TOWN HALL RENOVATIONS - ADDENDUM 01

Project: BERLIN TOWN HALL & ANNEX RENOVATIONS

Project No.: 2024-41

Date: DECEMBER 17, 2025

REVISED CEILING LEGEND

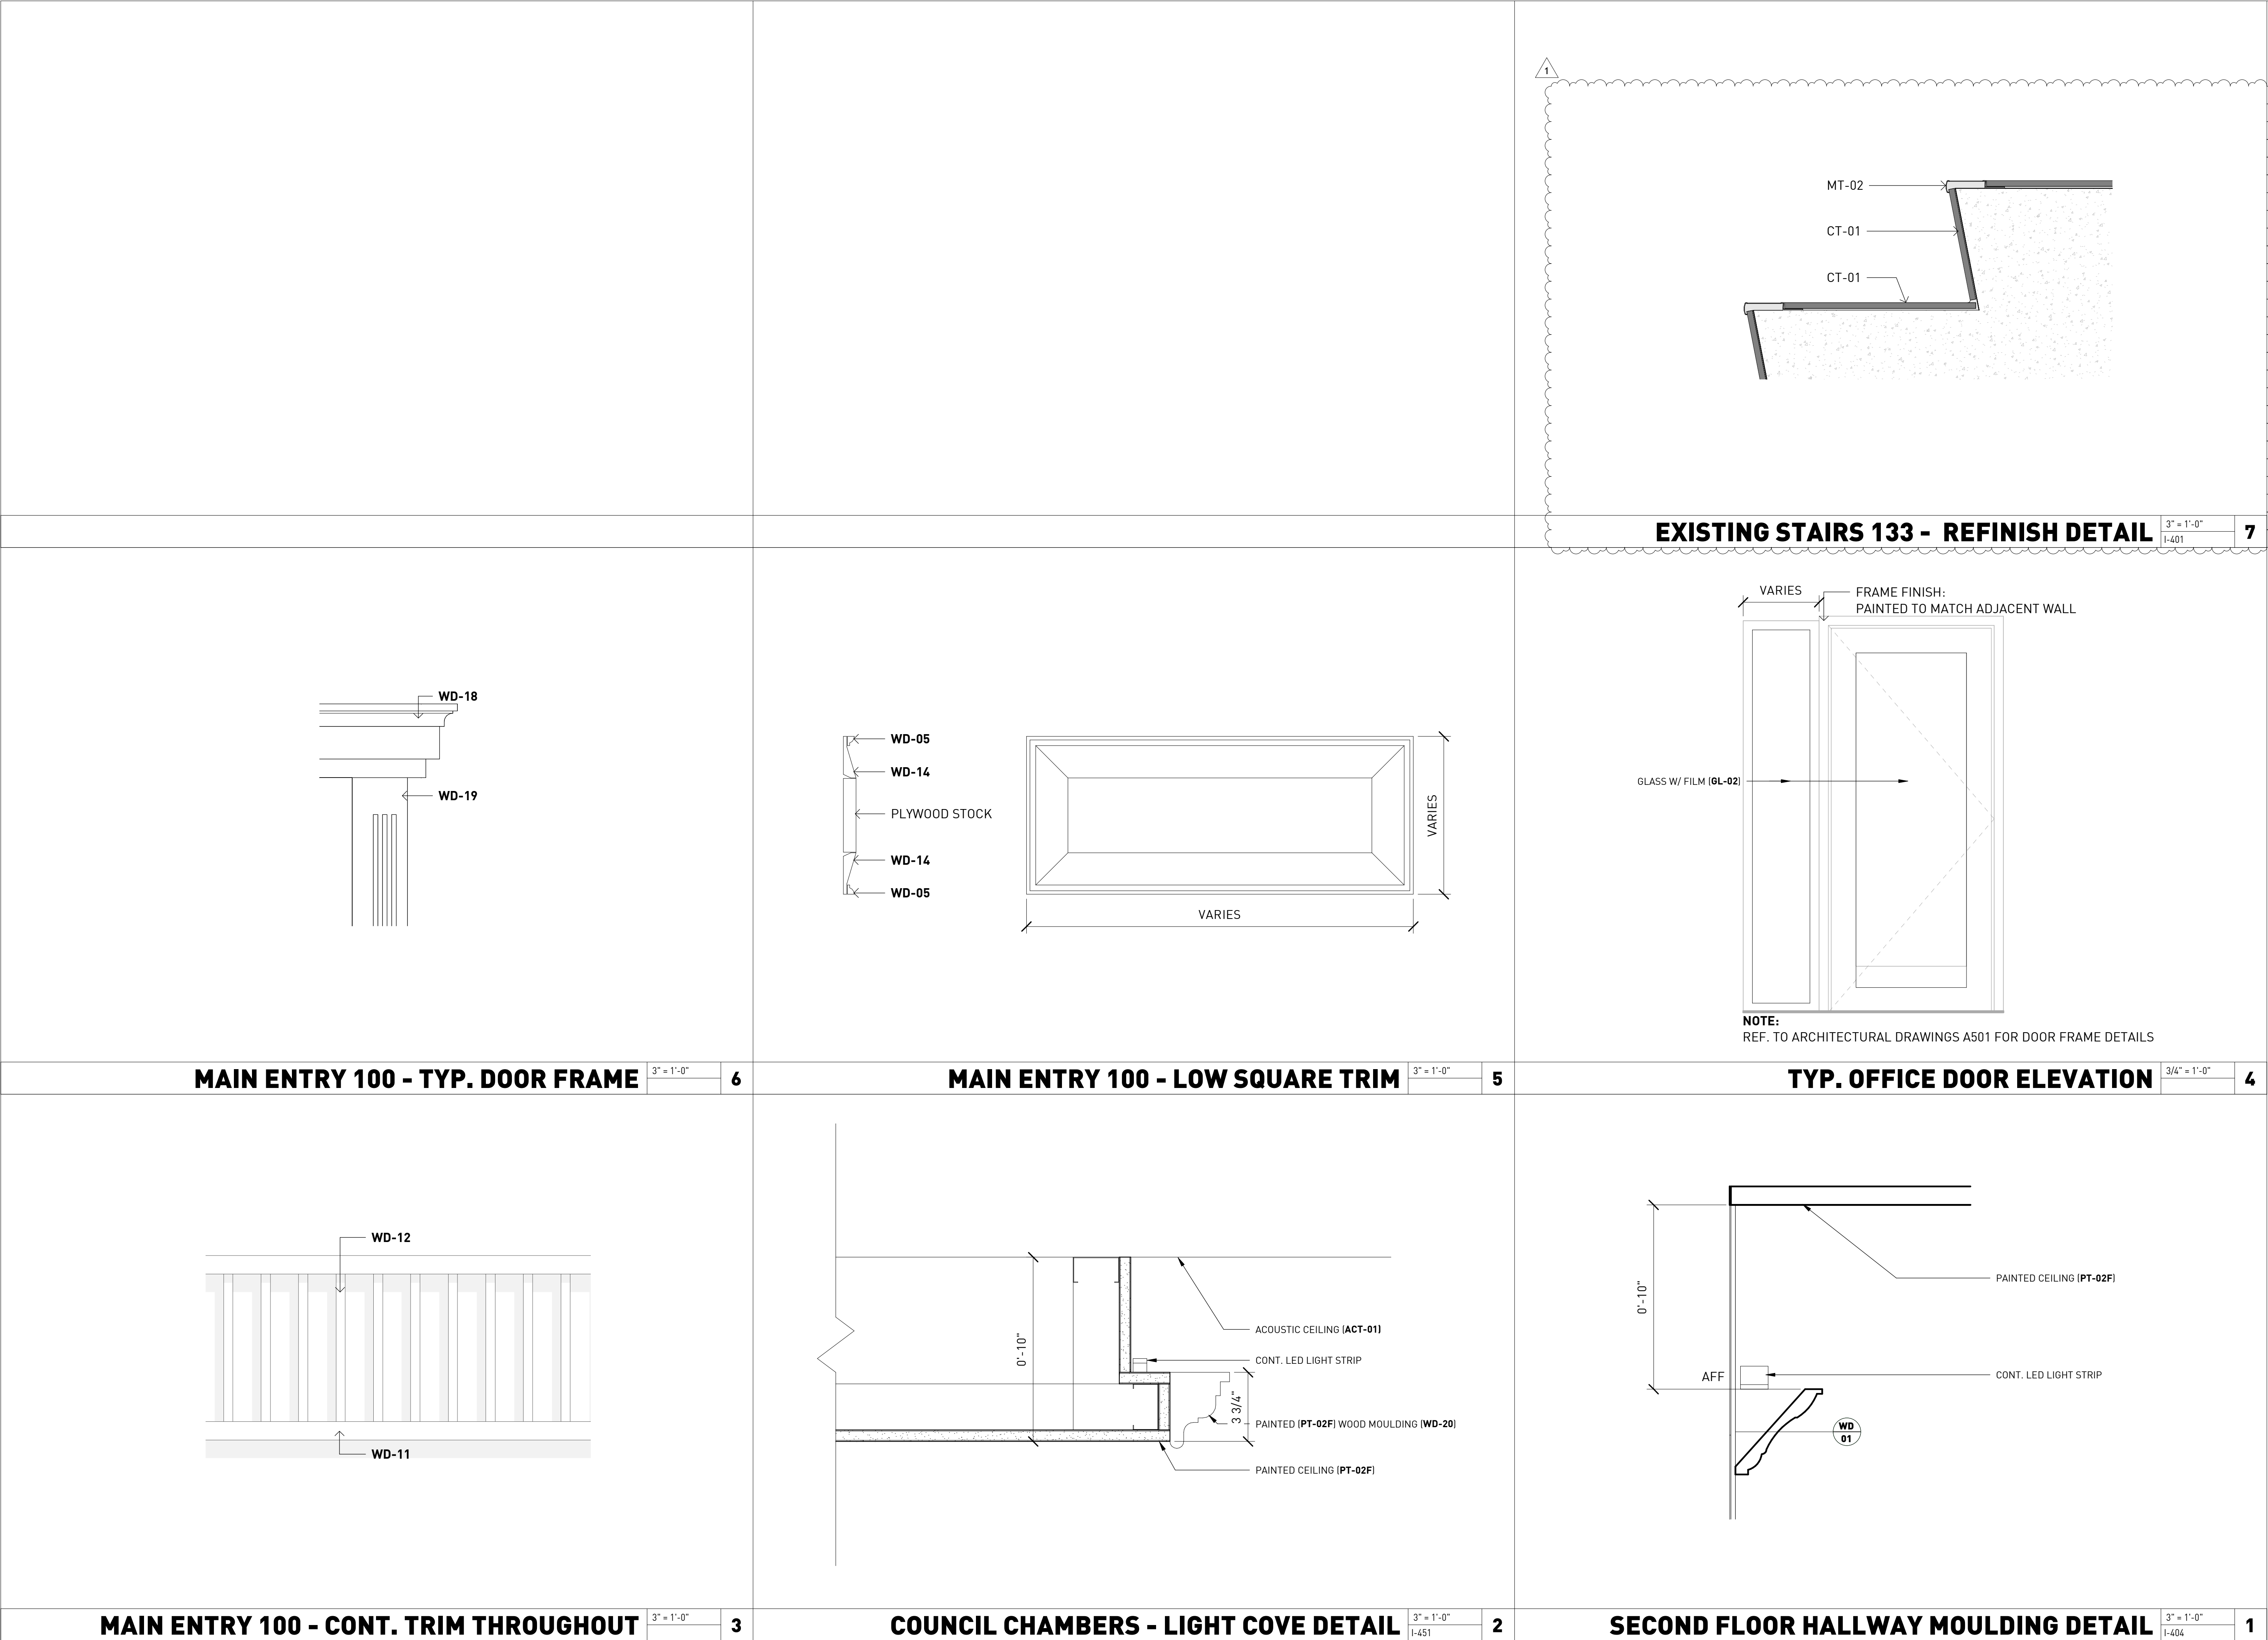
Sheet No.	Description of Revision
A-101A	REVISE CEILING LEGEND PER SKA-01 (ATTACHED)
A-104	REVISE CEILING LEGEND PER SKA-01 (ATTACHED)
A-105	REVISE CEILING LEGEND PER SKA-01 (ATTACHED)
I-002.1	REVISE NOTE 10. TO READ AS FOLLOWS: SR/A IS NOT RESPONSIBLE FOR OBTAINING ANY PERMITS OR COORDINATING ANY INSPECTIONS. CONTRACTOR TO COMPLY WITH ALL CODES, LAWS ORDINANCES, RULES, AND REGULATIONS OF ALL PUBLIC AUTHORITIES (FEDERAL, STATE OR LOCAL) GOVERNING THE WORK. THE MOST STRINGENT SHALL APPLY.
I-401	DELETE REQUIREMENT FOR MURAL AT ELEVATOR SHAFT. WALLS TO BE PT-01E.

ANSWER: YES.
9. **QUESTION:** Do you require PE stamped drawings/design for temporary shoring?
ANSWER: YES.
10. **QUESTION:** Referencing A104/A105 the finish legend states all gypsum board ceilings for the entire first floor/second floor. I am assuming you meant for the boxed out illustration to be acoustical ceilings. Please provide corrected sheet.

ANSWER: THE CEILING LEGEND IS SHOWN INCORRECTLY. SEE ATTACHED SKA-01 FOR REVISED CEILING LEGEND.
11. **QUESTION:** On walls that are existing, are you expecting new drywall?

I-602
Scale

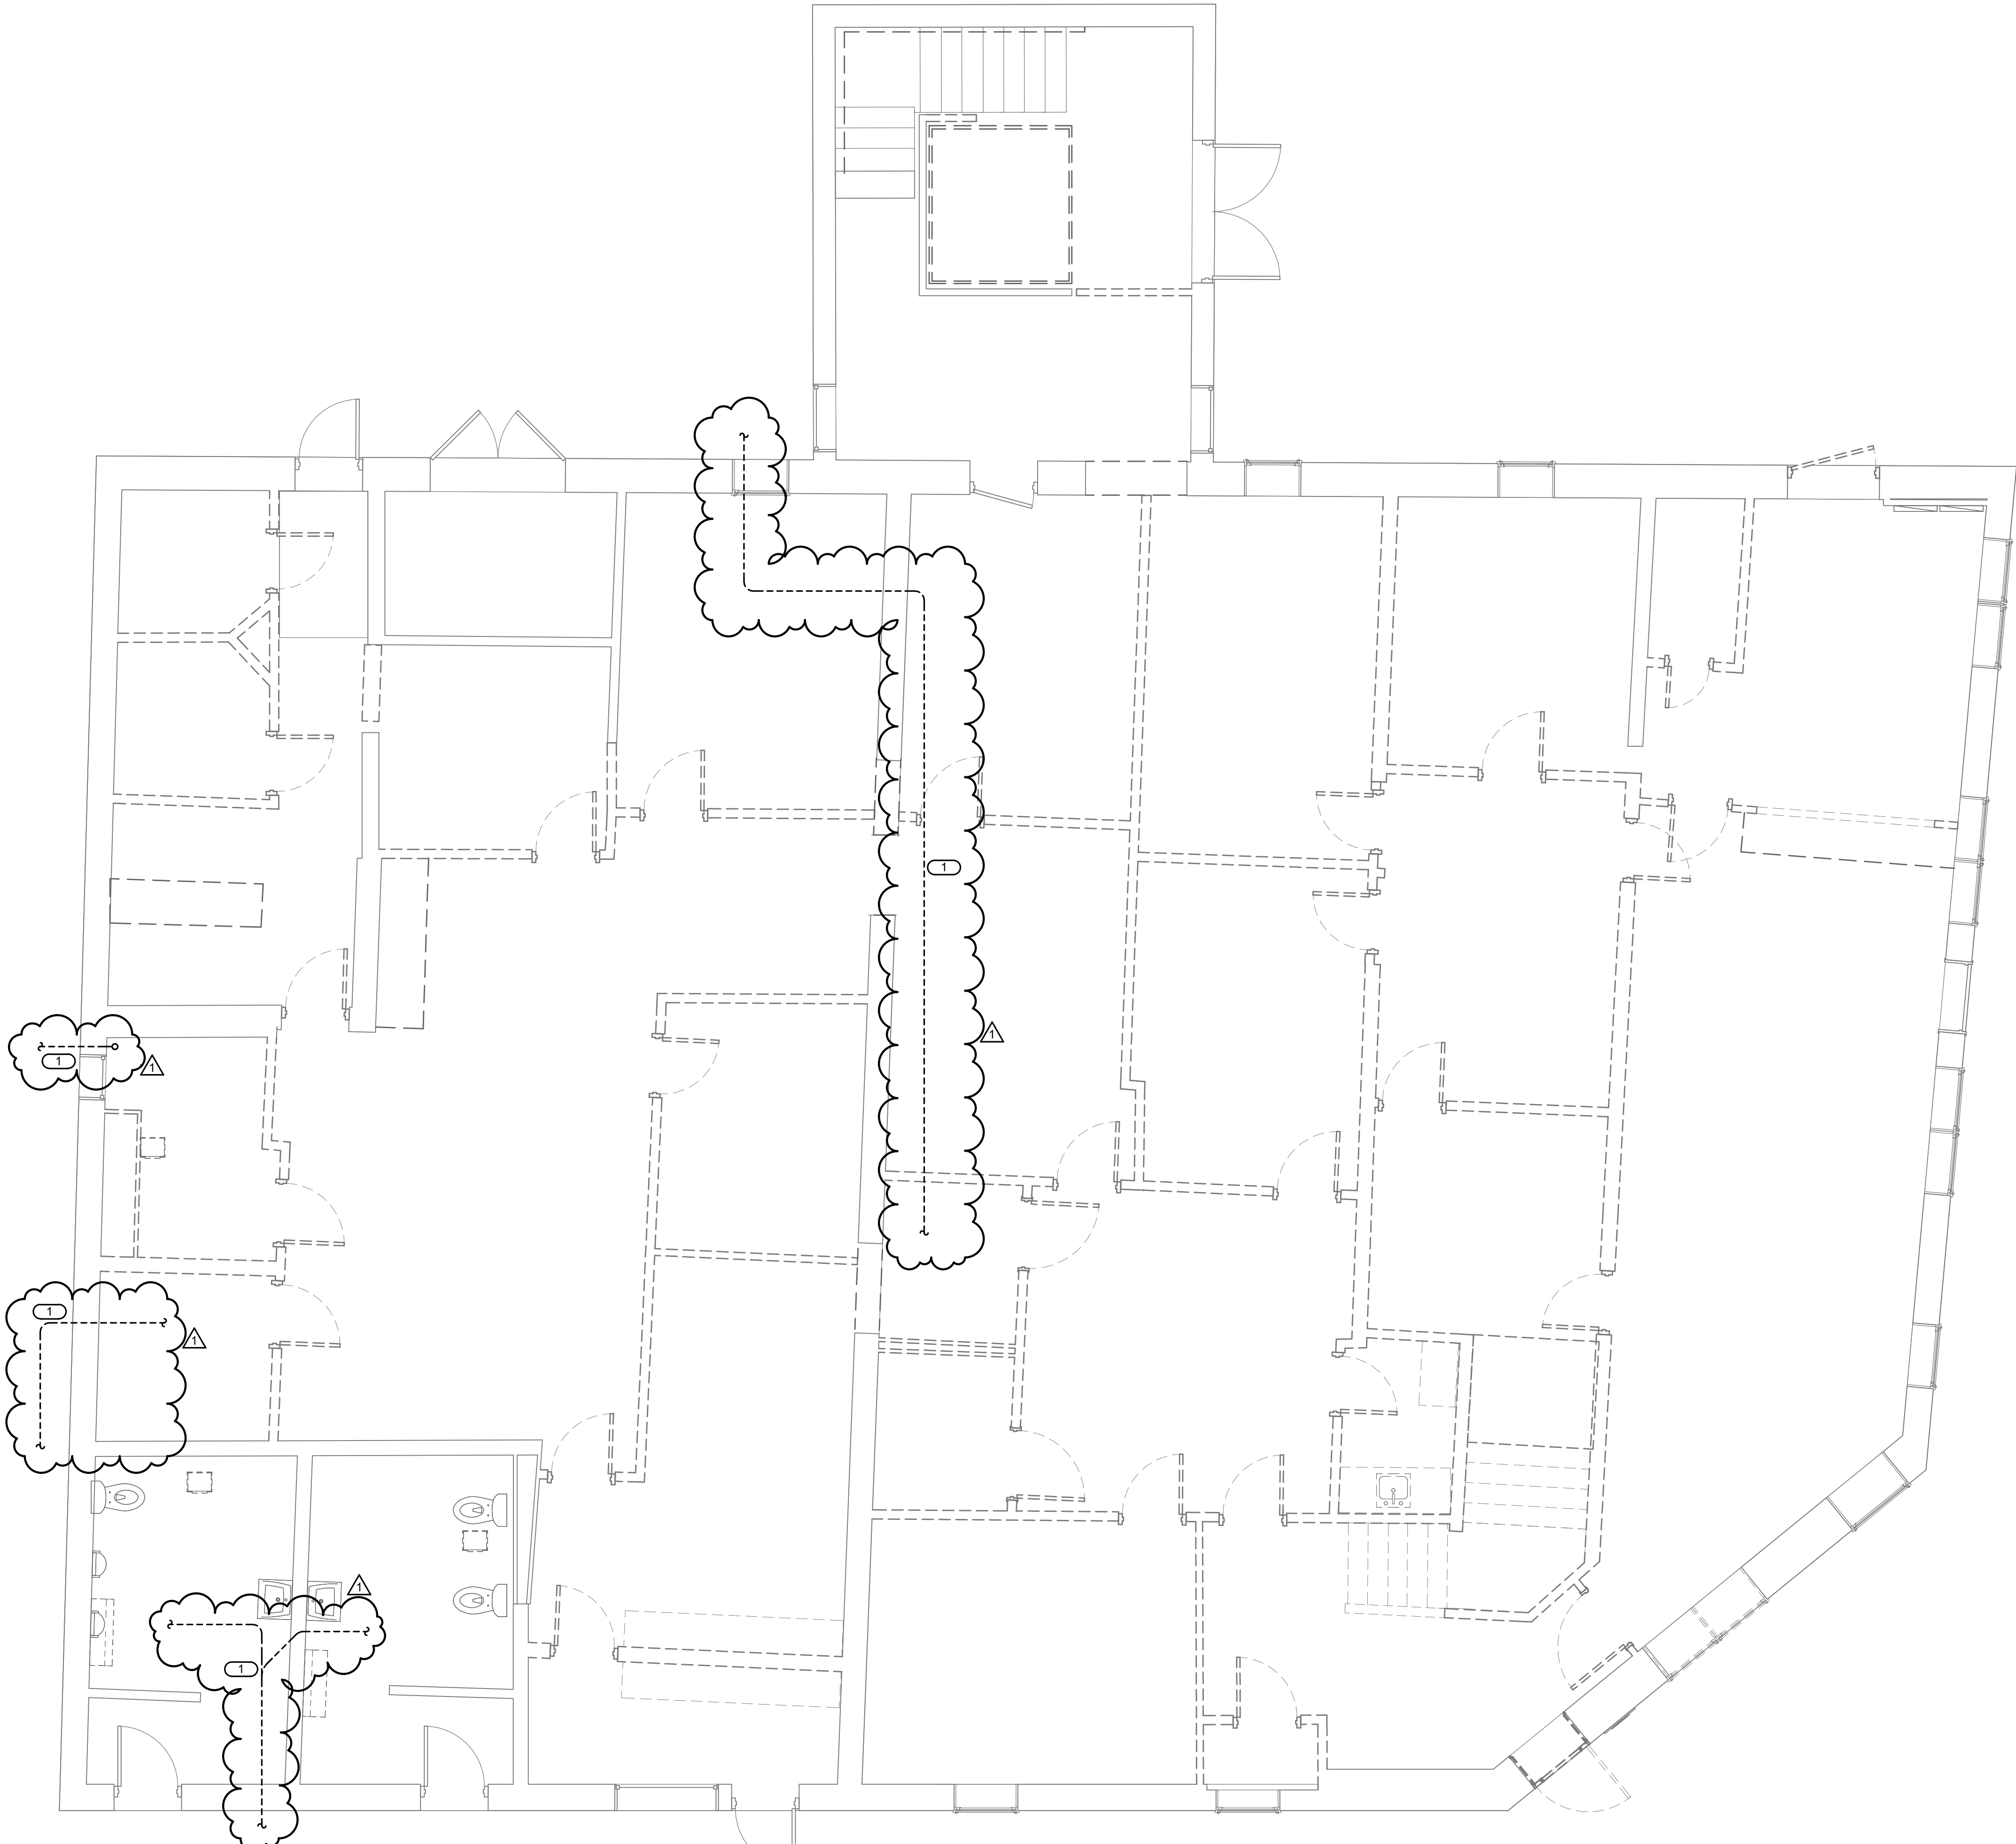
Sheet No.	Description of Revision
I-501	ADD DETAIL 7 – EXISTING STAIRS 133 – REFINISH DETAIL (ATTACHED)
I-601	DELETE NOTE FOR ADD/ALT. MURAL ON ROOM 220 STAIR TOWER
I-602	UPDATE STAIR PARTS SCHEDULE (ATTACHED)
P100	UPDATED PLUMBING UNDER FLOOR DEMOLITION PLAN (ATTACHED)
P101	DELETE GENERAL NOTE 1 IN ITS ENTIRETY
P102	ADD KEYNOTE 2. VIF LOCATION OF EXISTING VENT THROUGH ROOF AND REMOVE. PATCH ROOF PENETRATION.
P200	UPDATED PLUMBING UNDER FLOOR PLAN (ATTACHED)
P201	UPDATED LEVEL 01 PLUMBING PLAN (ATTACHED)
P500	UPDATED PLUMBING DIAGRAMS (ATTACHED)
P600	UPDATED PLUMBING SCHEDULES (ATTACHED)

14. **QUESTION:** Monumental Stair Rail – Reference 6/A402 and I-413 – confirm materials and finish of stair rail.
ANSWER: MATERIALS AND FINISHES OF STAIR COMPONENTS HAVE BEEN REVISED FOR CLARITY. SEE REVISED SHEET I-602.

STAIR PARTS SCHEDULE						
MARK	TYPE	MANUFACTURER	PRODUCT	NUMBER	FINISH	DIMS.
SP-01	NEWEL POST	WOOD CARVED SHOP	FLUTED COLONIAL NEWEL	NP041-POP-42-6	STN-01	
SP-02	BALUSTER	STAIR RAIL DIRECT	POPLAR 1-3/4" REEDED CAROLINA	4415RPOP	STN-01	36" TALL
SP-03	BALUSTER	STAIR RAIL DIRECT	POPLAR 1-3/4" REEDED CAROLINA	4415RPOP	STN-01	39" TALL
SP-04	HAND RAIL TYPICAL	STAIR RAIL DIRECT	CLASSIC HAND RAIL	6210	STN-01	
SP-05	HAND RAIL RIGHT HAND GOOSENECK AT LANDING	STAIR RAIL DIRECT	CLASSIC RIGHT HAND GOOSENECK 2 RISER	7255	STN-01	
SP-06	HAND RAIL LEFT HAND GOOSENECK AT LANDING	STAIR RAIL DIRECT	CLASSIC LEFT HAND GOOSENECK 2 RISER	7250	STN-01	
SP-07	RETURN END (AT TOP OF STAIRS)	STAIR RAIL DIRECT	CLASSIC 4"	7209	STN-01	
SP-08	WALL RAIL BRACKET	STAIR RAIL DIRECT	HEAVY DUTY BRACKET	1032HD	ANTIQUE BRASS	
SP-09	BULLNOSE TREAD	STAIR RAIL DIRECT	OAK 11-1/2"	8071O	STN-01	
SP-10	RISER	STAIR RAIL DIRECT	OAK RISER	8080	STN-01
